Our reference: ACTHDFOI22-23.30

### DECISION ON YOUR ACCESS APPLICATION

CALVARY PUBLIC HOSPITAL BRUCE - FIRE SAFETY RISK ASSESSMENT  
LCE22680-007

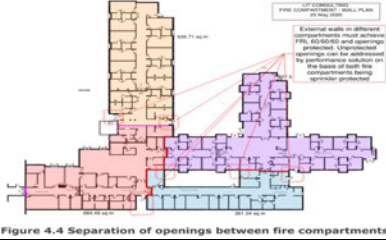
1.03	Sprinklers	Operating Theatre on Level 2 has undergone refurbishment in 2017 with below ceiling sprinklers compliant to Ordinary Hazard 1 classification under AS 2118:1999 and above ceiling sprinklers compliant to Lighting Hazard classification. Block plan at site shows sprinkler system was upgraded in 2002 in compliance with AS 2118.	Not having appropriate baseline data. Compliance issues are not picked up as part of testing and maintenance.	Minor	Possible	Moderate	Action 1. An audit has been carried out by Form1 which informs which areas have which hazard classification sprinkler heads. This is yet to be assessed by the consultant team to provide a gap analysis between actual and current design compliance.	Minor	Possible	Moderate		This work will be completed as part of the Dry Fire Stage 2 project
